UNITED STATES
NUCLEAR REGULATORY COMMISSION
WASHINGTON, D. C. 20555

The Commission has issued the enclosed Amendments Nos. 103, 103, and 100 to Licenses Nos. DPR-38, DPR-47 and DPR-55 for the Oconee Nuclear Station, Units Nos. 1, 2 and 3. These amendments consist of changes to the Station's common Technical Specifications (TSs) in response to your request dated October 28, 1981, as supplemented on October 29, 1981.

These amendments revise the TSs to allow full power operation of Oconee Nuclear Station Unit 2 with the Axial Power Shaping Rods in the fully inserted position.

SAFETY EVALUATION BY THE OFFICE OF NUCLEAR REACTOR REGULATION

APSR POSITION LIMITS FOR
OPERATION
FROM 150 ± 10 EFPD TO
390 ± 10 EFPD
Unit 2 - 30
OCONEE NUCLEAR STATION
Figure 3.5.2-4B2

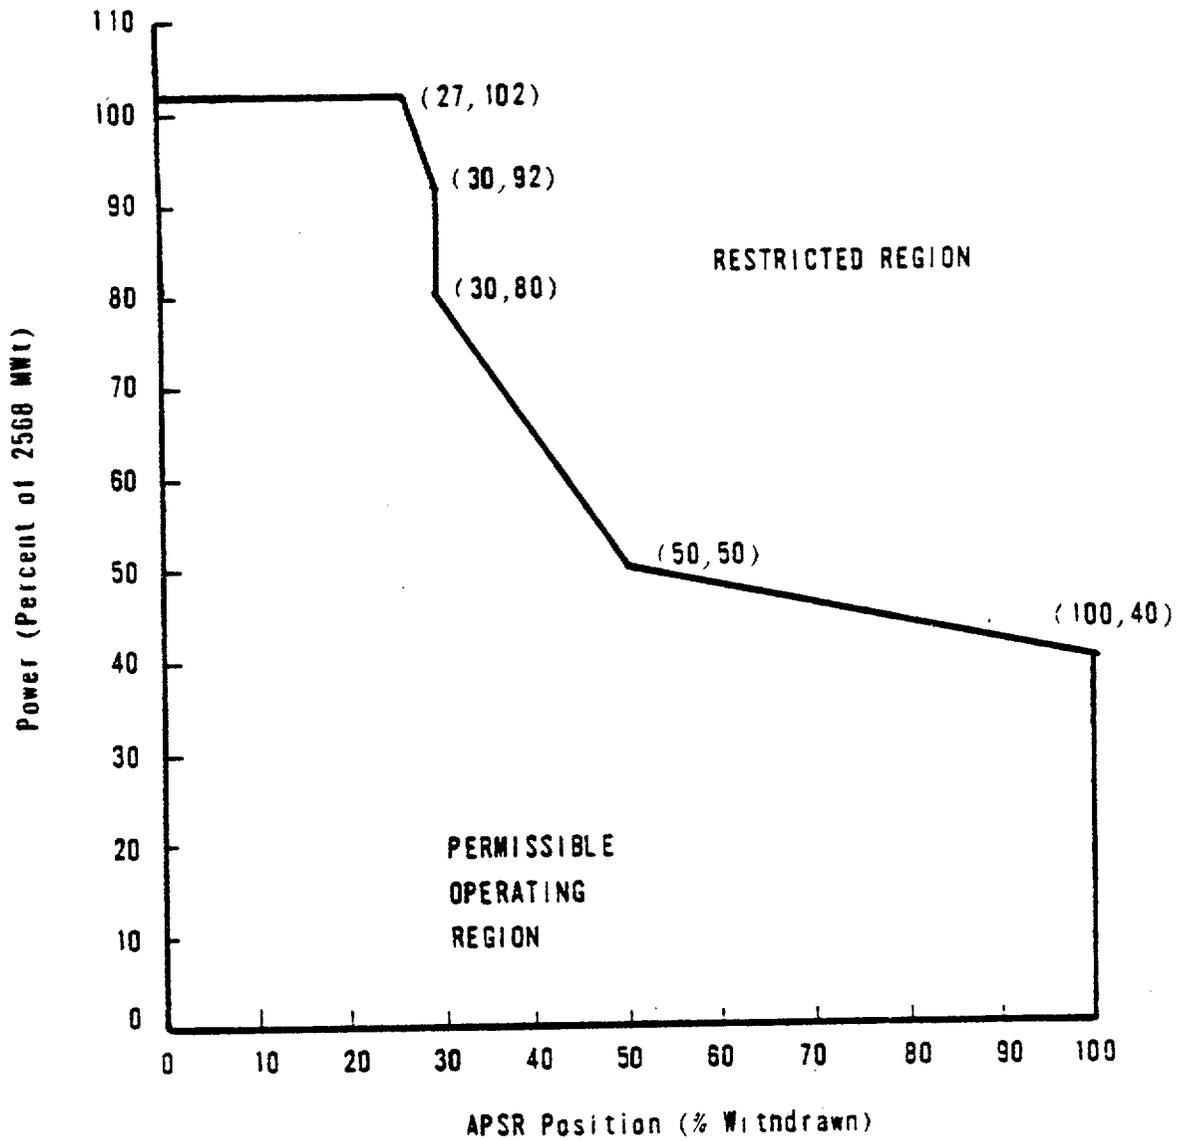
Replace page 3.5-25a of the Appendix "A" Technical Specifications with the attached page. The revised page is identified by amendment numbers and contains a vertical line indicating the area of change.

The current ONS TS limits associated with APSR position (contained on Figure 3.5.2-4B2) for Oconee 2 operation require the APSRs to be withdrawn 6% from the fully inserted position for full power operation. Operation up to 80% of full power operation is permissible with the APSRs in the fully inserted position. Because of the concern mentioned above, Duke, by letter dated October 28, 1981, requested a change to allow full power operation with the APSRs in the fully inserted position.

The present requirement for 6% withdrawal of the APSRs was discussed by Duke in a supplemental letter dated October 29, 1981. This letter states that the reason for the required slight withdrawal is twofold: 1) to prevent unacceptable power peaking toward the end of fuel cycle, and 2) to prevent the APSRs from becoming trapped in the fully inserted position by power imbalance and peaking considerations.

The analysis performed by B&W indicated unacceptable power peaking could occur if the APSRs were fully inserted in the core early in the fuel cycle. Reexamination of the analysis indicates that for end of cycle, accounting for the control rod and APSR positioning that has been maintained during this cycle, unacceptable power peaking should not occur with the APSRs fully inserted. (The power peaking limitations define the linear heat rate values used as initial assumptions in the LOCA analyses performed in accordance with Appendix K to 10 CFR 50.46.) Therefore, operation with the APSRs in the fully inserted position will not violate the limits used in the LOCA analyses.

We have reviewed this information and the existing TSs. Since TS limitations will remain unchanged for Xenon Reactivity (3.5.2.6) and Power Imbalance (3.5.2.7), assurance is maintained that unacceptable core power configurations will not develop. In addition, no reactor protective features will be changed because the APSRs are not included in the automatic shutdown system. Therefore, based on the considerations discussed above and the fact that only a short period of operation remains during Cycle 5 operation, we find the proposed change to the ONS Unit 2 APSR position limits to be acceptable.
